re: **Grading and Site Servicing Plans Review**
Proposed Residential Development
222 Baseline Road – Ottawa, Ontario

date: October 20, 2025

file: PG6324-MEMO.01

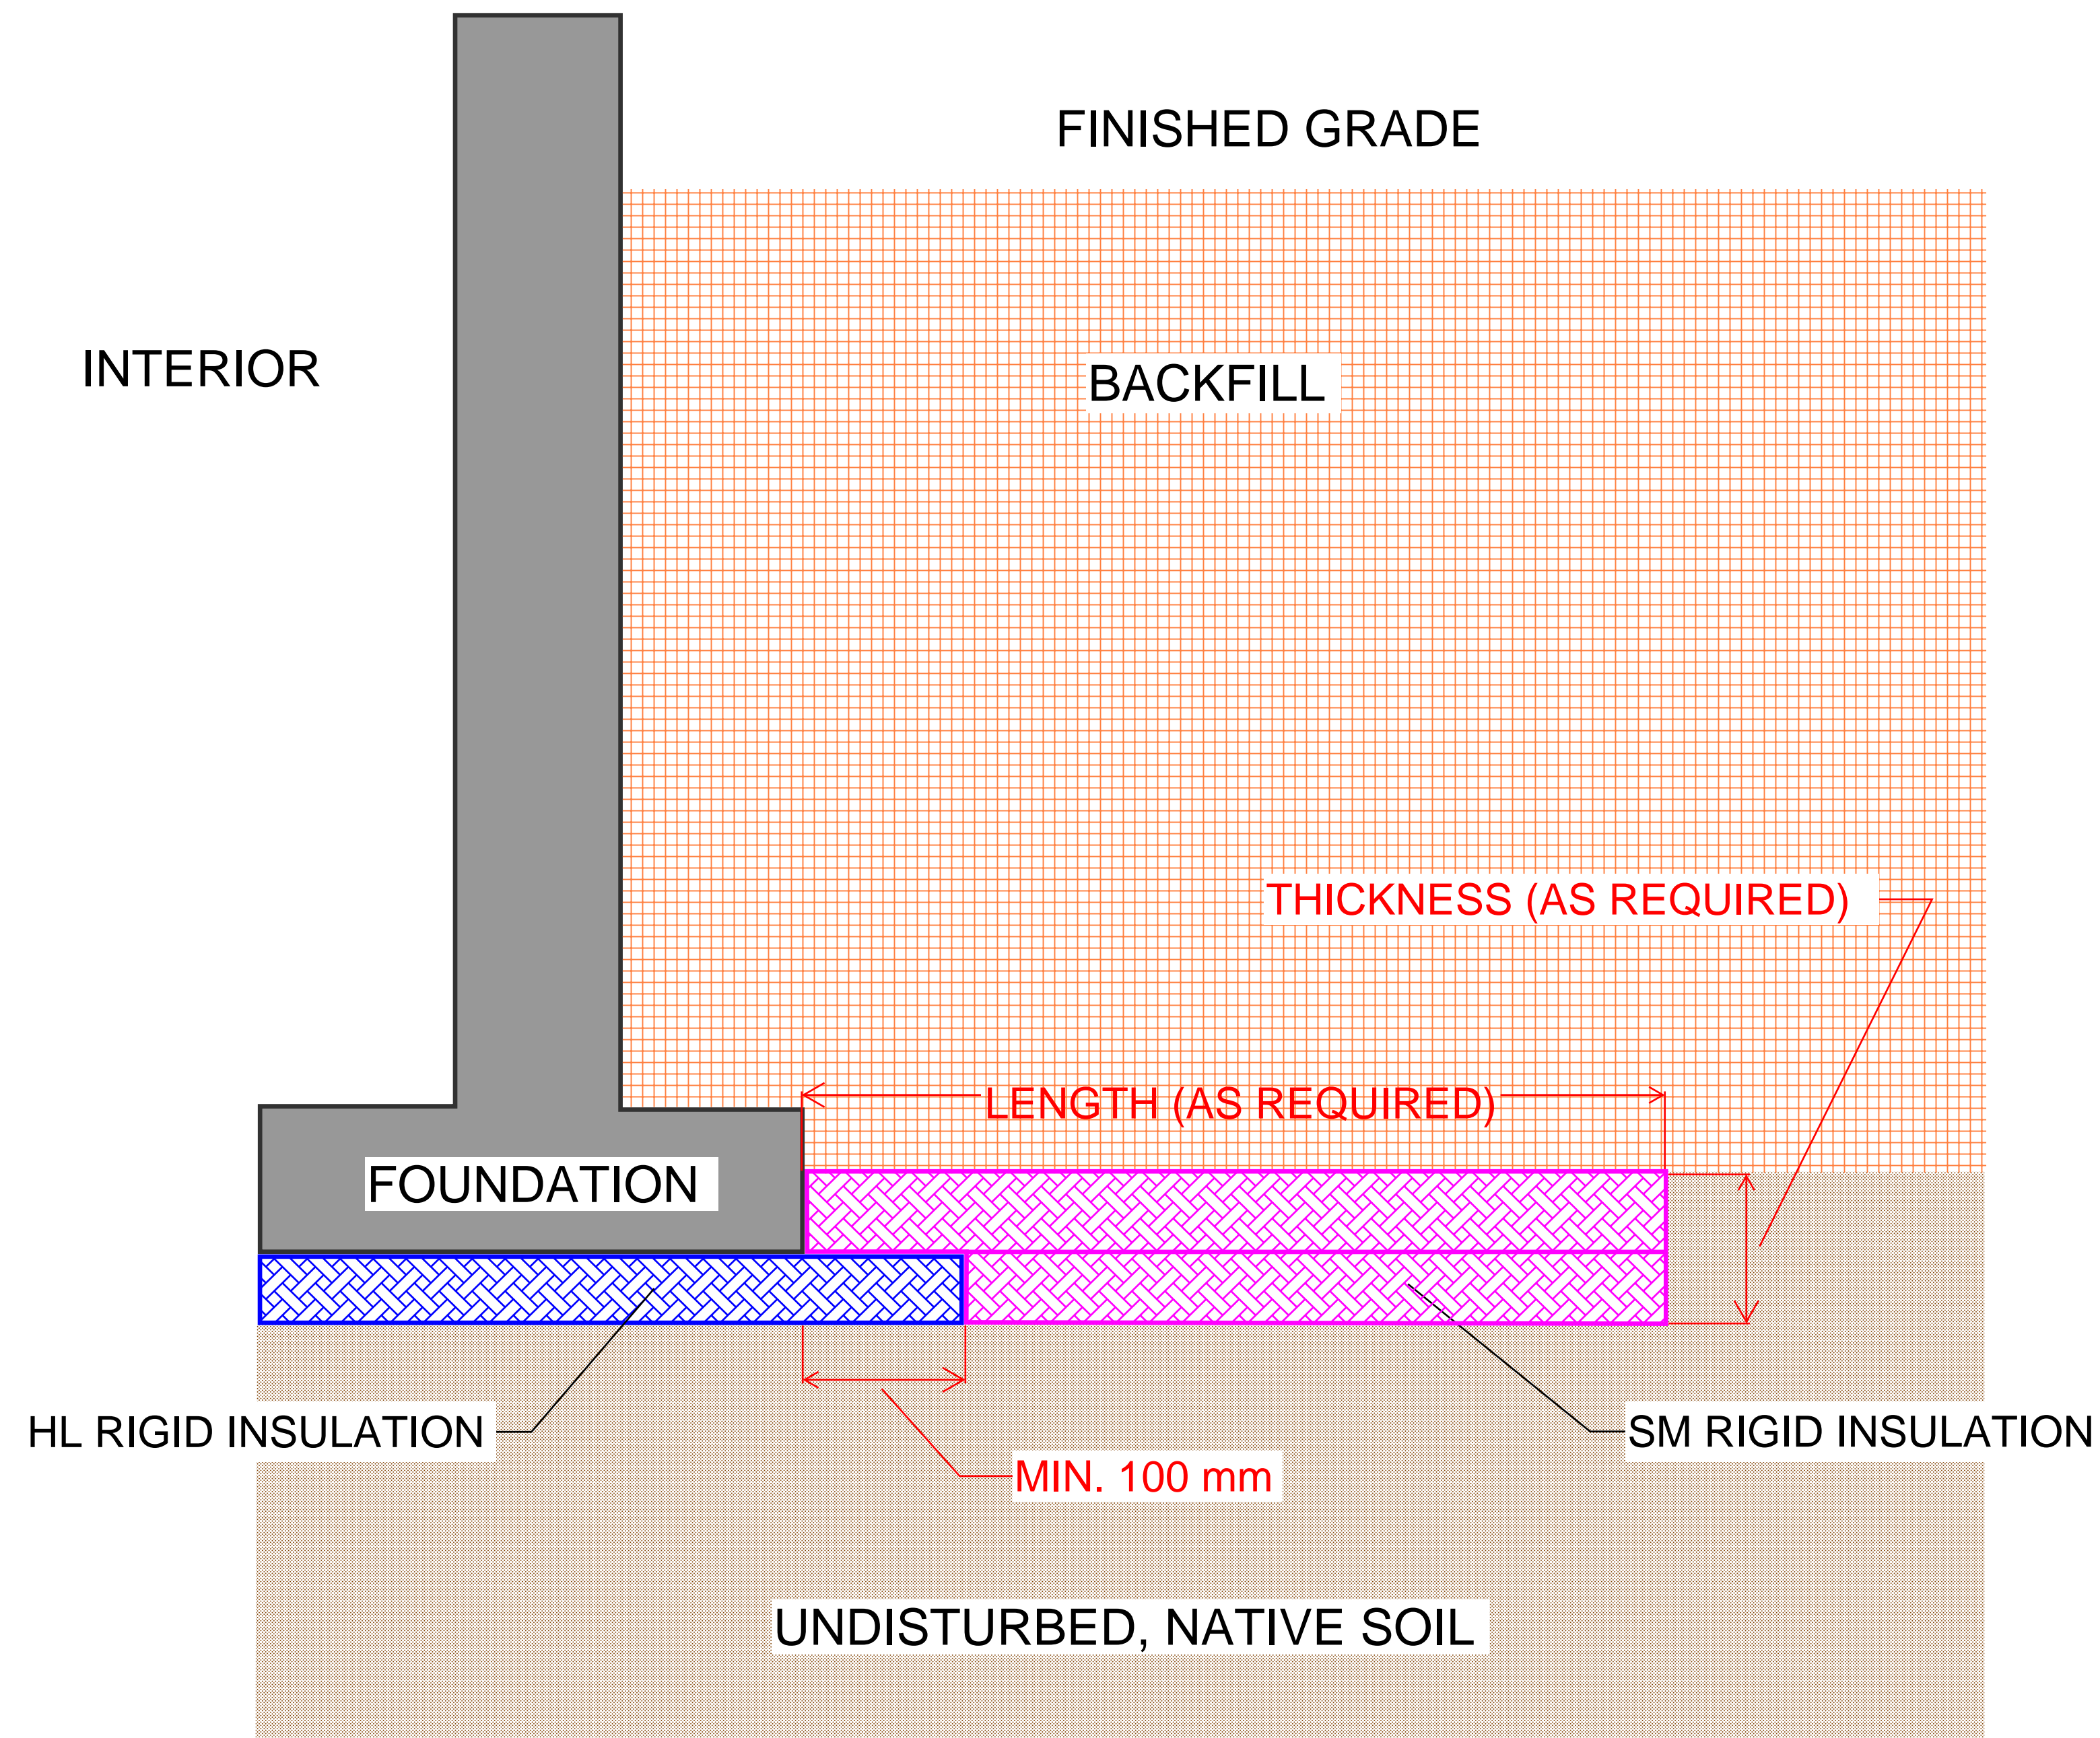
All rigid insulation placed below the footings should consist of either Dow Chemical High-Load 40 (HL-40), Styro Rail SR.P400, or equivalent approved by Paterson. The rigid insulation placed below the footings should extend a minimum of 100 mm beyond the exterior edge of the footing. Styrofoam (SM) rigid insulation can be used beyond to extend beyond the footing face (above USF). Reference should be made to Figure 3 – Typical Rigid Insulation Detail, attached to this memorandum.

All rigid insulation should consist of either Dow Chemical High-Load 40 (HL-40), Styro Rail SR.P400, or equivalent approved by Paterson. The placement of all insulation within the service trenches must be reviewed and approved by Paterson personnel at the time of construction. Reference should be made to Figure 3 – Typical Rigid Insulation Detail, attached to this memorandum.
